PUBLIC IMPROVEMENT CONSTRUCTION PLANS
WOODMEN FRONTAGE RD. TURN LANE
FOR
CHALLENGER COMMUNITIES, LLC
BENTGRASS MEADOW DR. & WOODMEN FRONTAGE RD.
FALCON, CO 80831 EL PASO COUNTY

GRADING & EROSION CONTROL PLAN

GEC_V3.pdf Markup Summary 5-19-2022

Glenn Reese - EPC Stormwater (7)

G1.1

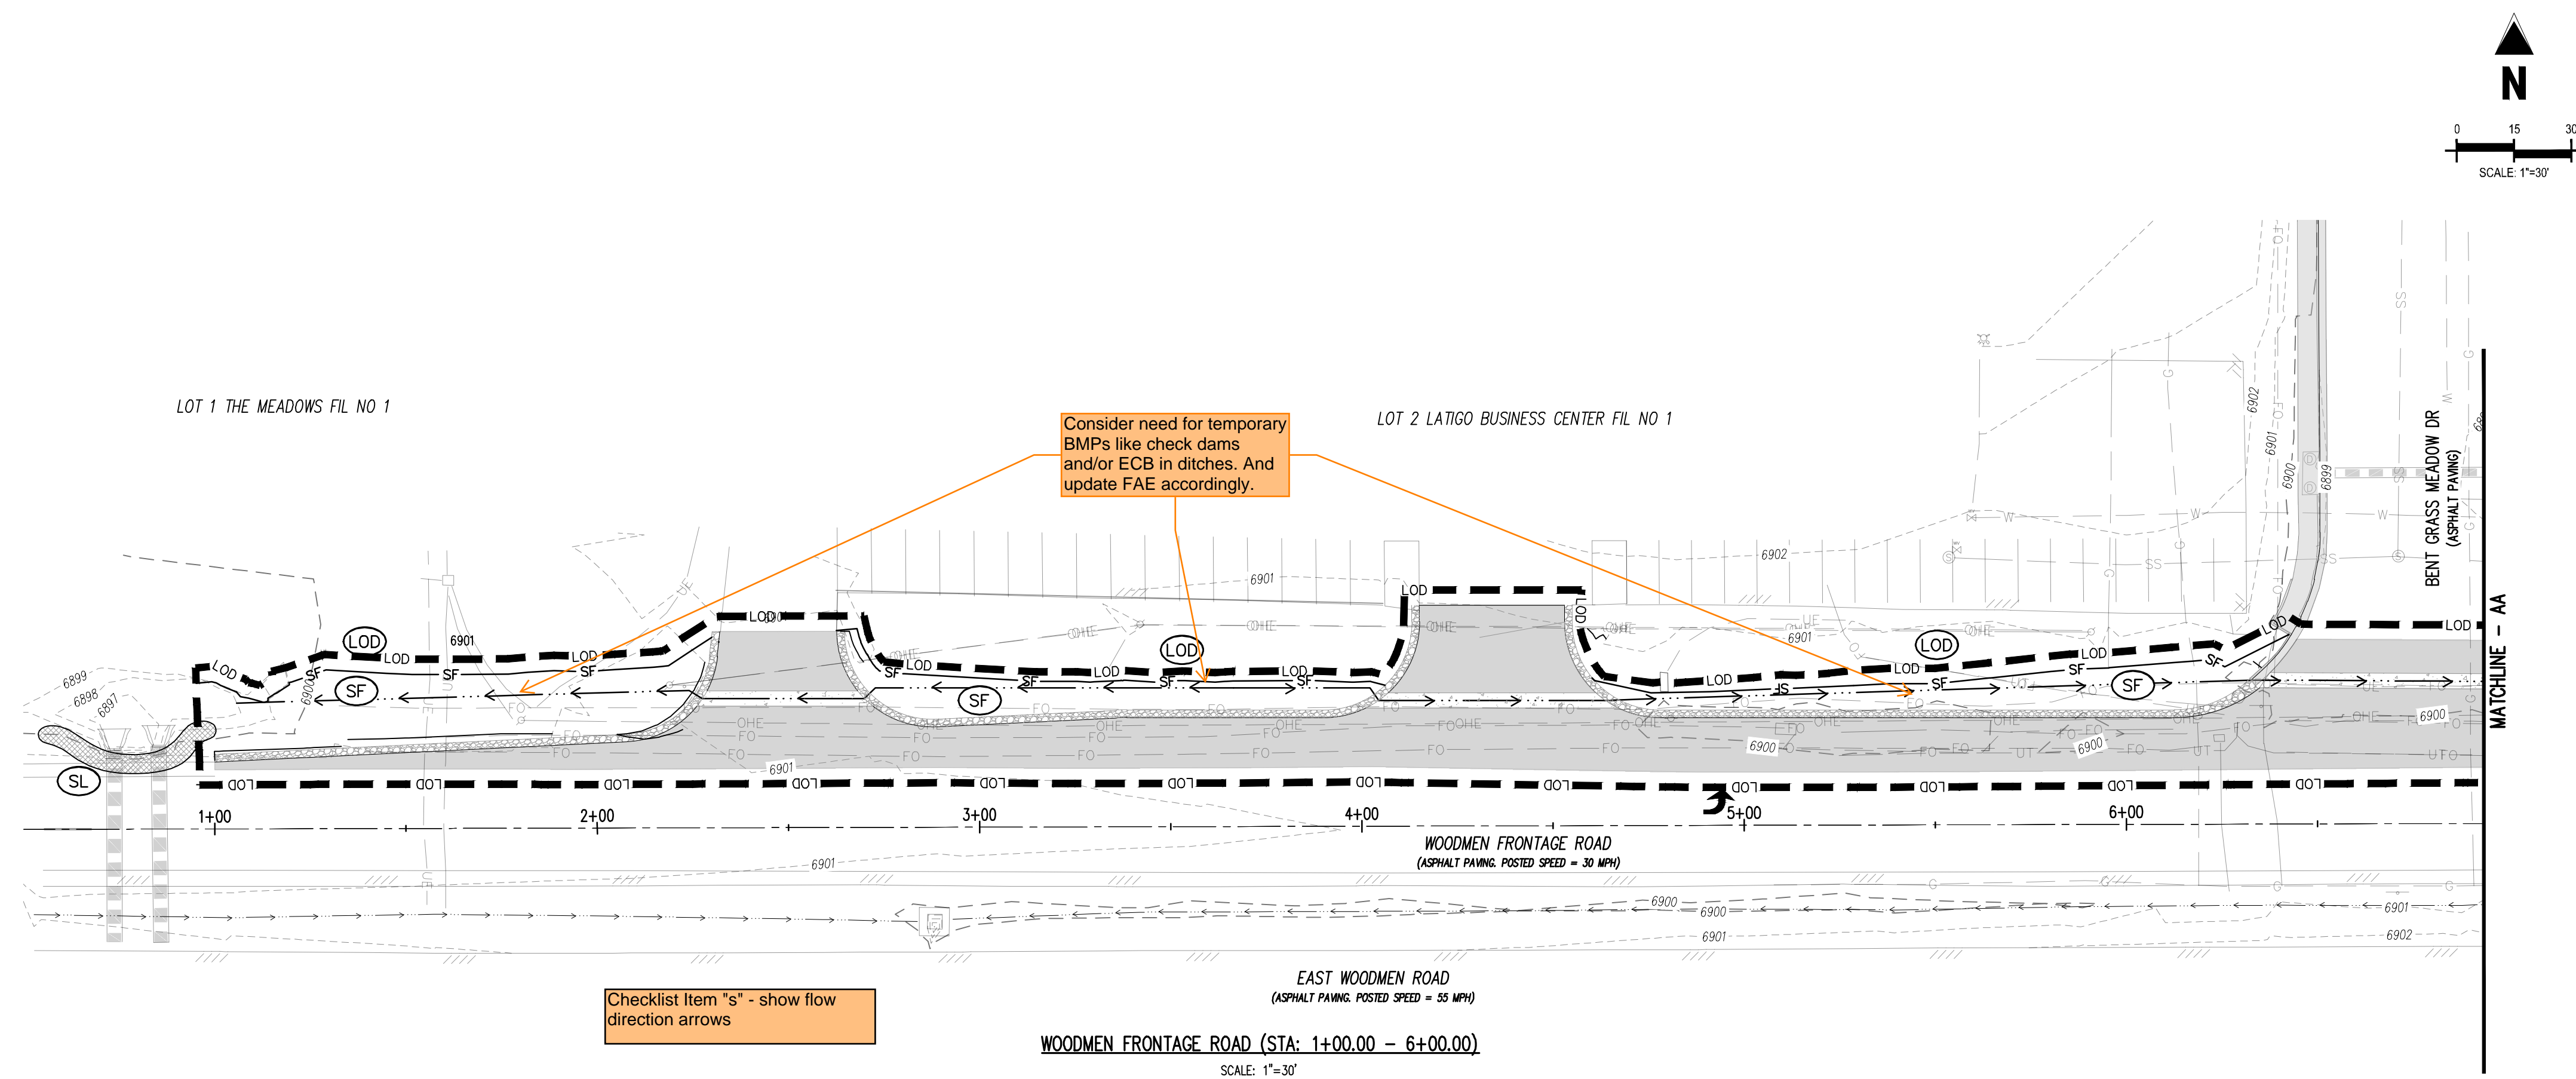
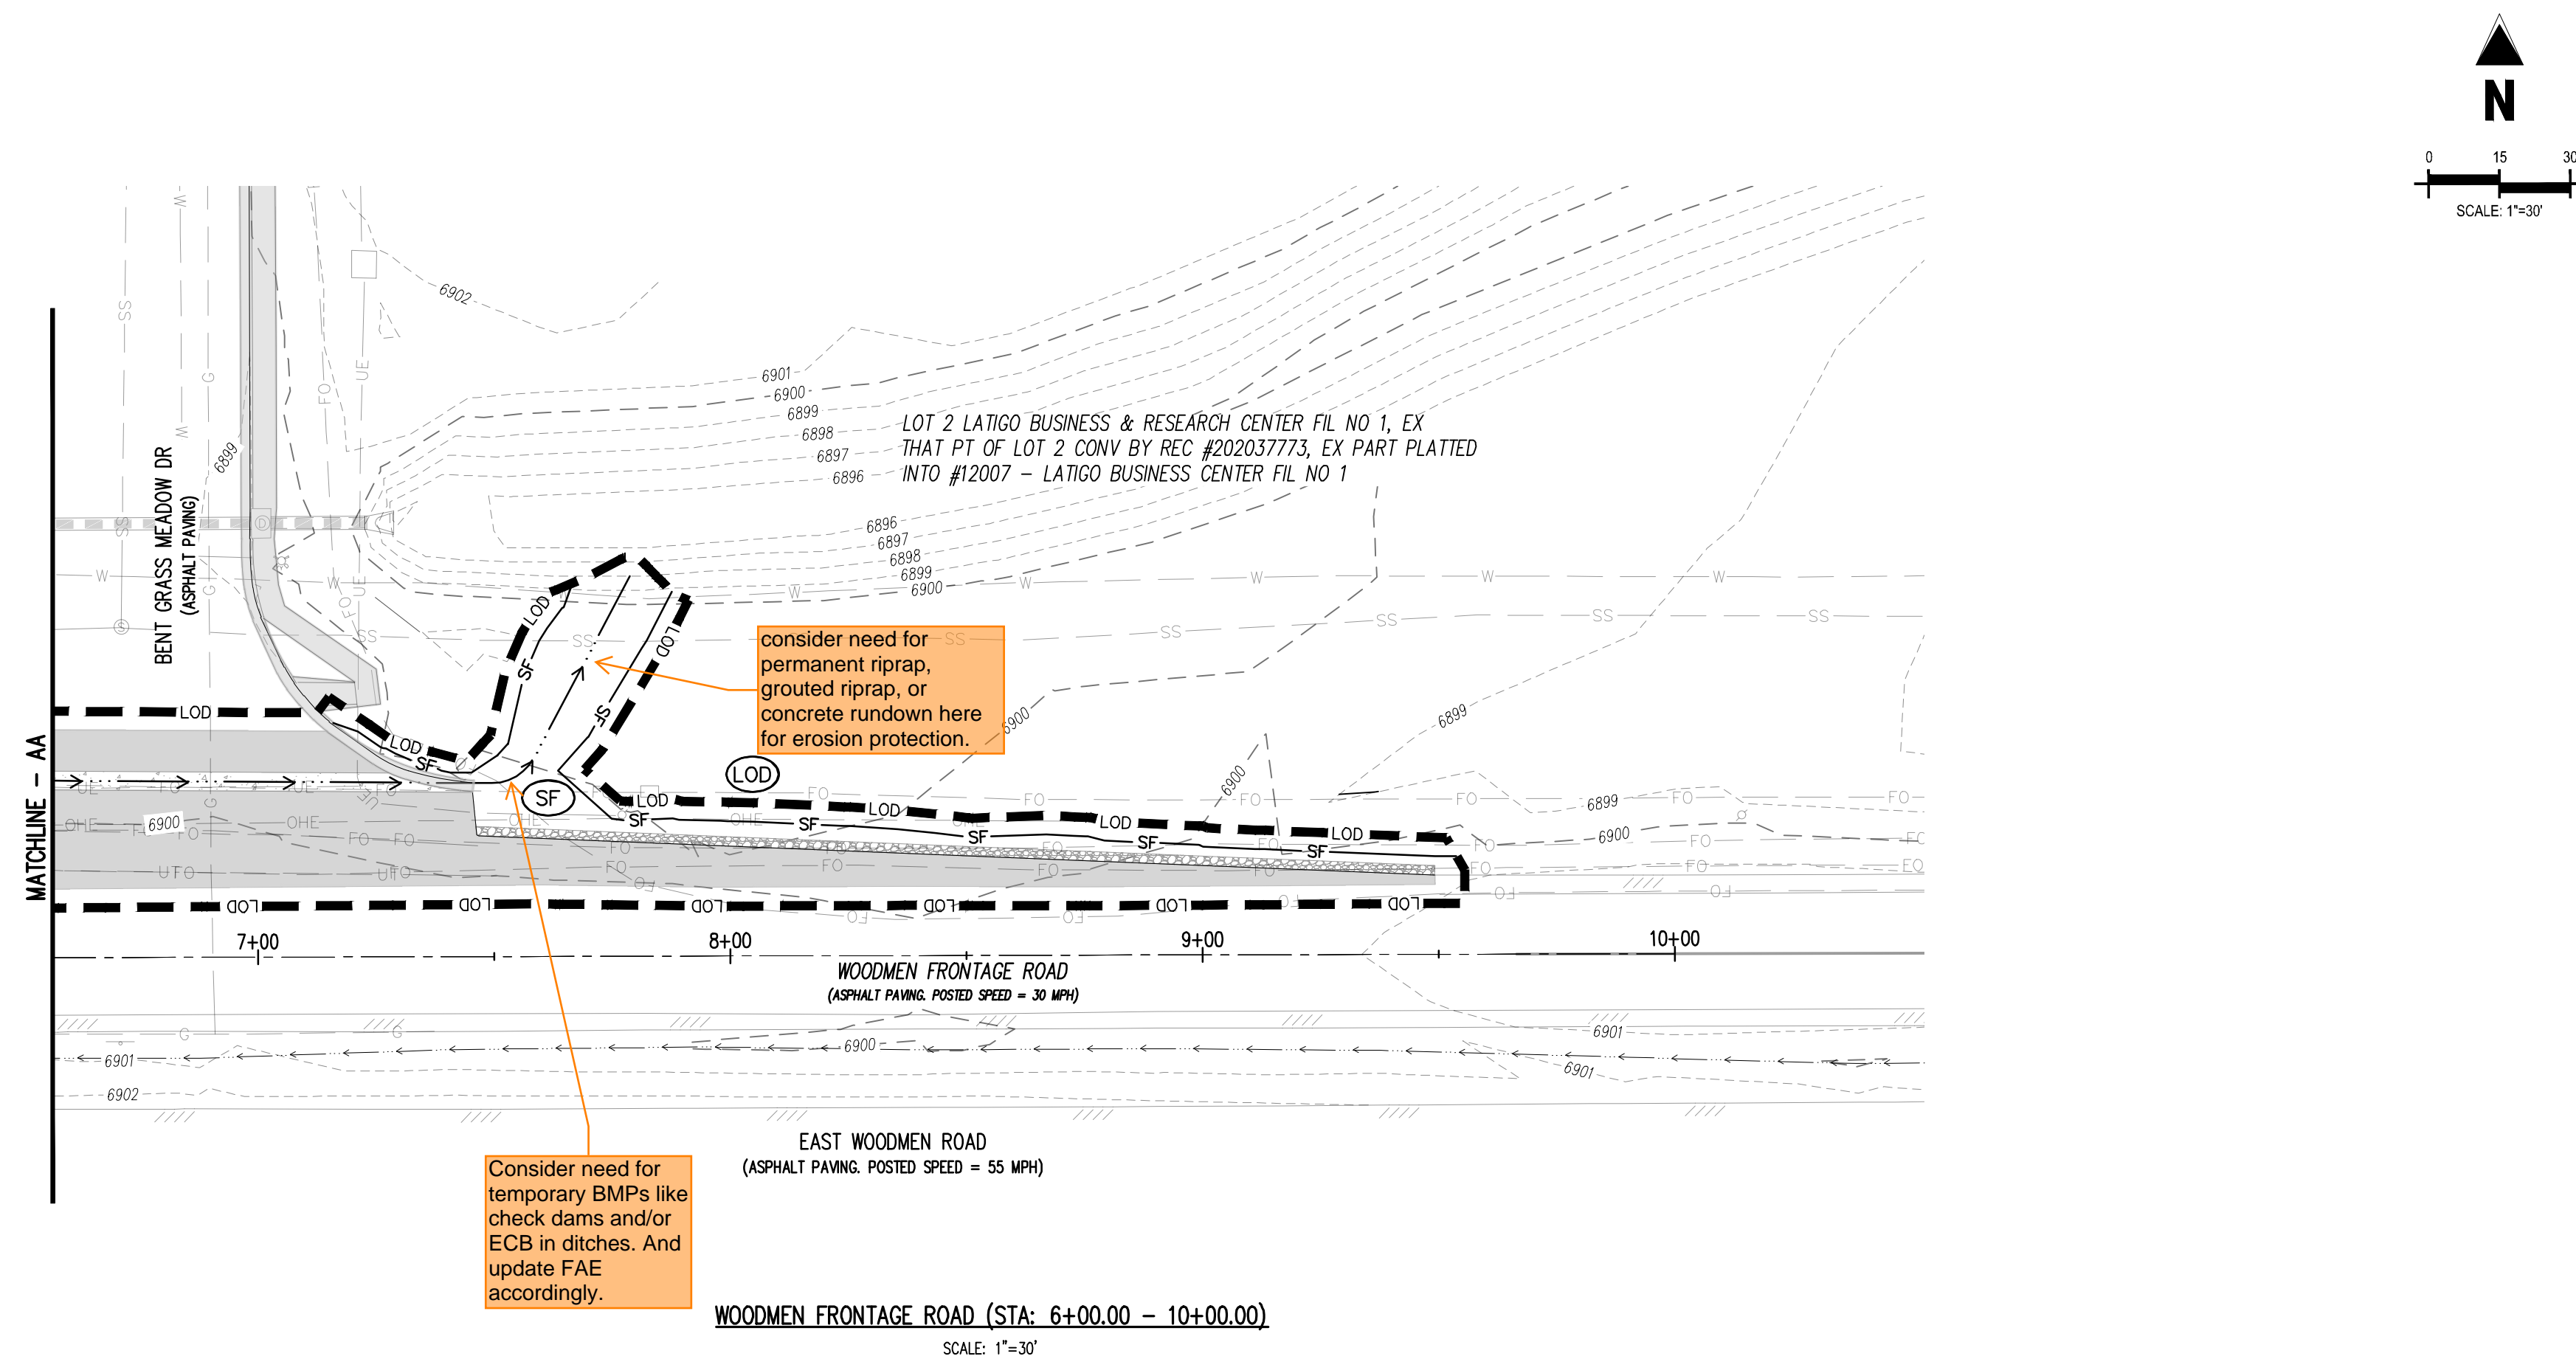
Items H and M. If "limits of disturbance" and "construction boundary" are the same, change to "limits of construction/disturbance" or otherwise show as separate line types for each on the legend and figure.

Consider need for temporary BMPs like check dams and/or ECB in ditches. And update FAE accordingly.

Checklist Item "s" - show flow direction arrows

consider need for permanent riprap, grouted riprap, or concrete rundown here for erosion protection.

Consider need for temporary BMPs like check dams and/or ECB in ditches. And update FAE accordingly.
